# UNITED STATES PATENT AND TRADEMARK OFFICE

APPLICATION NO.	FILING DATE	FIRST NAMED INVENTOR	ATTORNEY DOCKET NO.	CONFIRMATION NO.
10/036,303	12/28/2001	Frank Hawley	ACT-307DVA	2755

<b>Office Action Summary</b>	<b>Application No.</b> 10/036,303	<b>Applicant(s)</b> HAWLEY ET AL.	
	<b>Examiner</b> Anh D. Mai	<b>Art Unit</b> 2814

## DETAILED ACTION

FIG. 1A

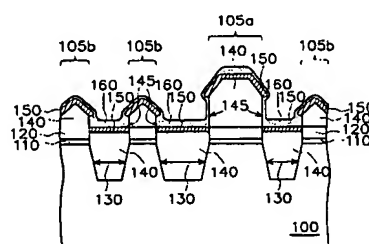
To disprove the Applicants assertion that an article having a same number should be the same. Attention is directed to the U.S Publication No. 20020137305. In the drawing Fig. 1A, below, all active region are designate 105b and all of the trenches are designate 130.

Are the active region (105b) the same size ?

Are the trenches (130) the same size and uniform cross-section ?

U.S. Patent Jun. 1, 1999 Sheet 7 of 7 5,909,628

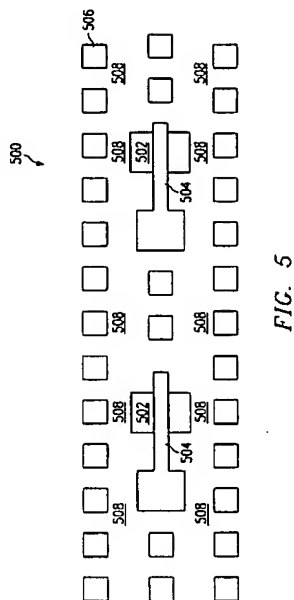
With respect to the declaration, as clearly indicated previously, the declaration had been considered. However, it is not effective because the uniform cross-section is not a must since trenches that isolate an active region can be different in shapes and sizes. (See Mehta '063). To further elaborate that point, Applicant is urged to review U.S. Patent No. 5,909,628, with Fig. 5 is included below.

The trenches (having a same number 508) that surround active region (502) do not seem to be the same in size and of course, do not seem to be: **must have uniform cross-section**.
